High Performance Cladding for use in Boiling Water Reactor Fuel

WCAP-18869-NP-A
Revision 0

**SUBJECT: FINAL SAFETY EVALUATION FOR WESTINGHOUSE ELECTRIC COMPANY
TOPICAL REPORT WCAP-18869-P/NP, REVISION 0, "HIGH PERFORMANCE
CLADDING FOR USE IN BOILING WATER REACTOR FUEL"
(EPID L-2024-TOP-0007)**

Figure 3-5 Nodular corrosion vs. annealing parameter

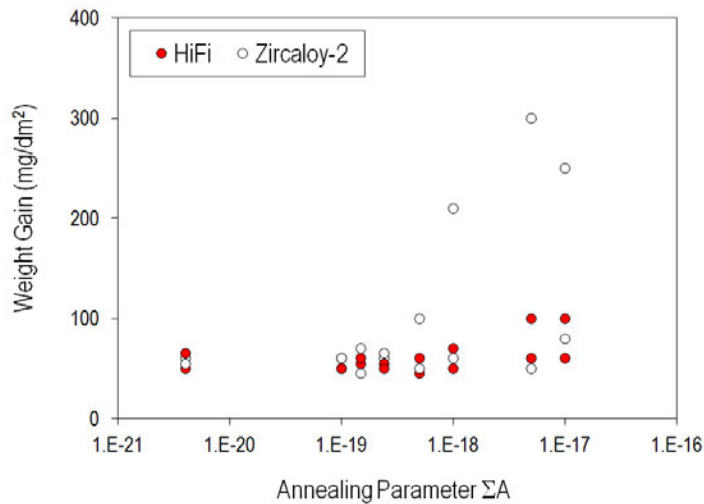
Westinghouse indicated in TR WCAP-18869-P/NP, Revision 0, that the plates of manufactured alloys were evaluated for nodular corrosion resistance by corrosion testing in steam at 525°C for 24 hours. As shown in Section 3.3.2, Figure 3-5 of the TR, the nodular corrosion resistance of Zircaloy-2 material is degraded as the annealing parameter ΣA is increased over 10^{-18} , as illustrated by the scatter in weight gain, while HiFi material maintains nodular corrosion resistance up to 10^{-17} .

Figure 3-6 High temperature steam oxidation

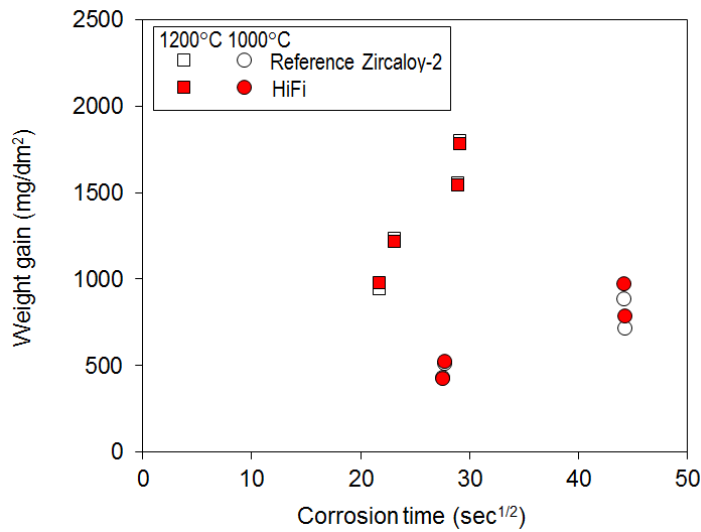
Based on the testing results shown in Figure 3-6 and Figure 3-7 in Section 3.3.3 of the TR, the NRC staff determined that the high temperature corrosion behavior of HiFi cladding is [

Figure 3-7 High temperature oxidation reaction rate constant (from Reference 16)**Figure 3-8 Correlation of burst hoop stress and cladding temperature**

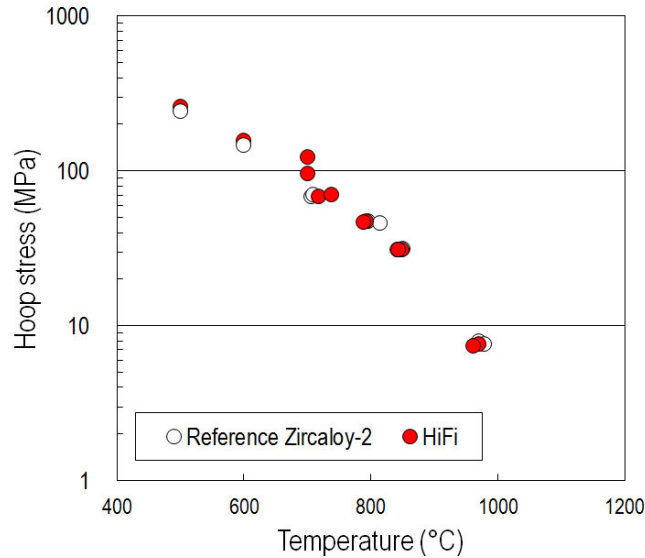
High temperature burst tests were performed and confirmed that the burst behavior for HiFi and Zircaloy-2 materials is very similar, as illustrated in Section 3.3.3, Figure 3-8 of WCAP-18869-P/NP, Revision 0. Furthermore, burst testing has been performed [

Figure 3-9 ECR value measured by quench tests

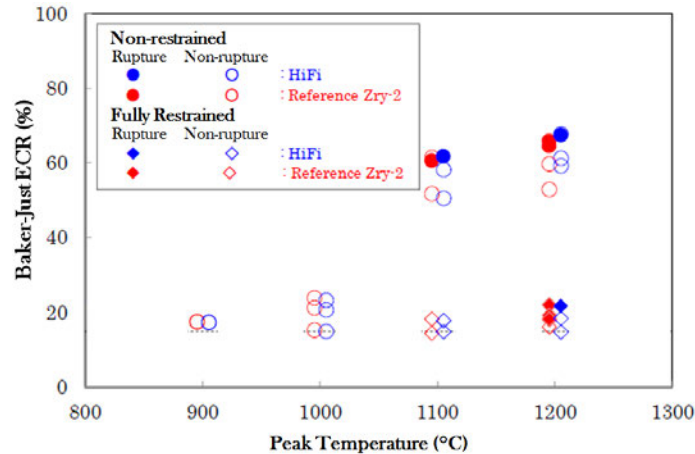
] based on the tests that were performed in axial non-restrained and fully restrained conditions during quenching in Figure 3-9 of the TR.

Figure 3-13 Hydrogen pickup fraction in K5 coupons

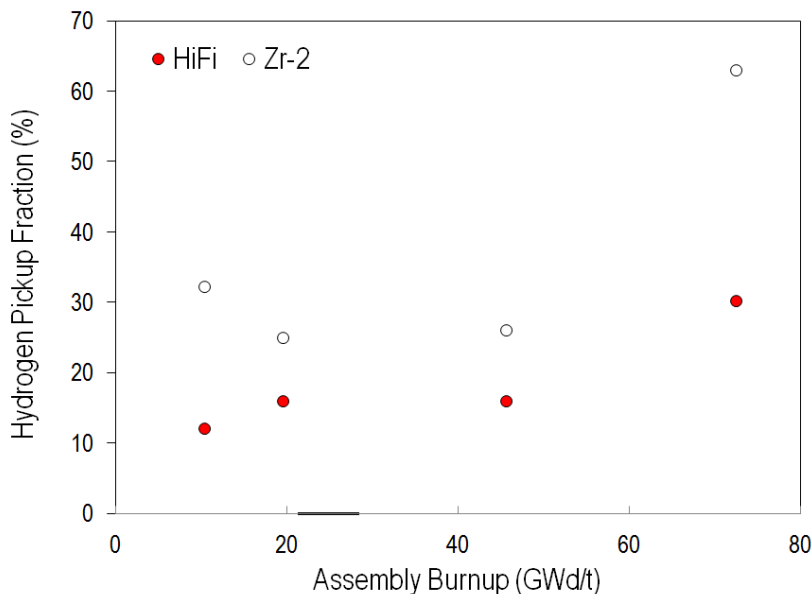
Figure 3-13 in TR WCAP-18869-P/NP, Revision 0, illustrates the hydrogen pickup fraction of the K5 coupons. In alignment with the out-of-pile tests, the uniform corrosion between Zircaloy-2 and HiFi cladding is comparable. However, the hydrogen pickup fraction of HiFi cladding is significantly lower than that of Zircaloy-2 cladding. For both materials, the hydrogen pickup fraction remains [

Figure 3-17 Fatigue results of K5 coupons at room temperature.

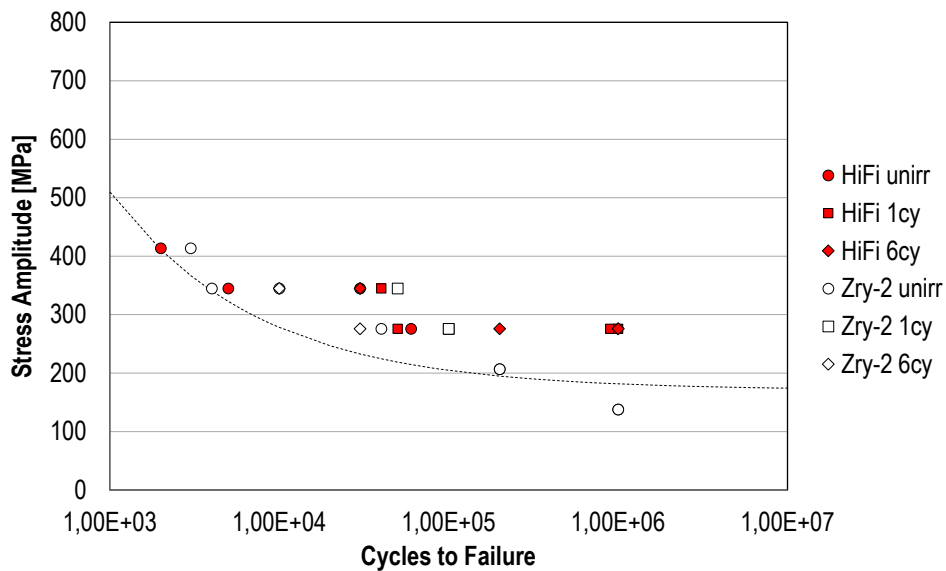
Evaluation: The fatigue limits derived by O'Donnell Langer are used for evaluation of cladding fatigue. In Figure 3-17 in TR WCAP-18869-P/NP, Revision 0, it is shown that the O'Donnell Langer curves bound the HiFi cladding fatigue behavior. The evaluation of fatigue is done with the NRC-approved BWR fuel performance code and relies on the mechanical behavior of the cladding (see Section 3.2.4.2 of WCAP-18869-P/NP, Revision 0).

Figure 3-18 OD measurements in pressurized []^{a,c} samples

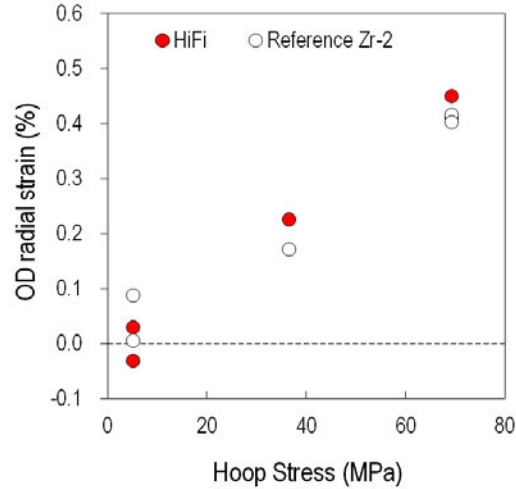
Closed specimens pressurized with noble gas were irradiated in K5 for 1,666 days. As shown in Figure 3-18 of TR WCAP-18869-P/NP, Revision 0, outer diameter (OD) measurements taken on these samples indicate that [

Figure 3-26 Corrosion of []^{a,c} fuel rods

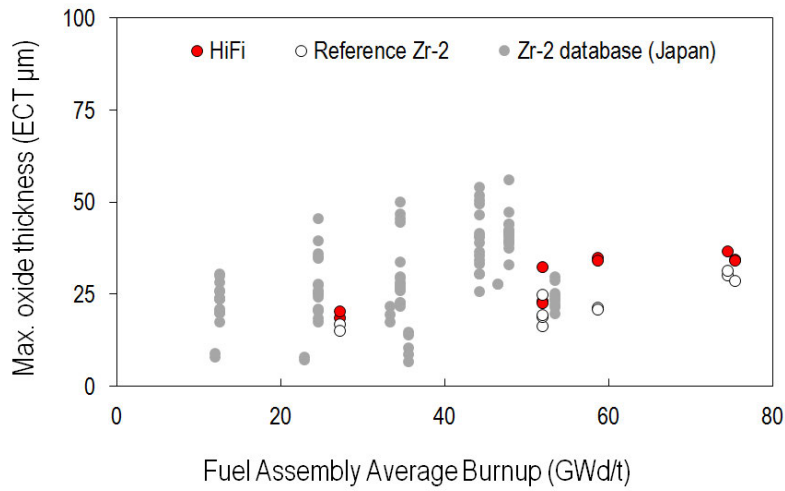
The oxide thickness measurements for the rods shown in Figure 3-26 in the TR WCAP-18869-P/NP, Revision 0, confirm that HiFi and Zircaloy-2 cladding []. The hydrogen content of the fuel rod, obtained in hot cell, is shown in Figure 3-27 of the TR. []
